DCN No. E970126-00-D

DOCUMENT CHANGE NOTICE (DCN)

DOCUMENT No. (DOC-REV-GP. ID)	TITLE	NEW REV.
D960785-A-D	RECYCLING MIRROR SUBSTRATE	B
E960092-A-D	SUBSTRATE, RECYCLING MIRROR	B

REASON FOR CHANGE: Update documentation to incorporate definition of wedges, change of radius of curvature and other details negotiated with the Polisher.

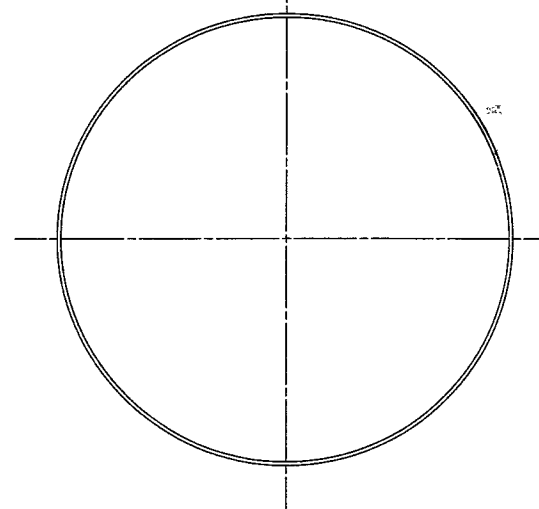
Wedge angle changed to 2 degrees 24 minutes

Tolerance of ± 30 minutes on location of registration mark WRT minimum thickness

Etch changed to "etch OR GRIND" in 3 places

Maximum thickness is changed to $97.5 +0, -0.5\text{mm}$
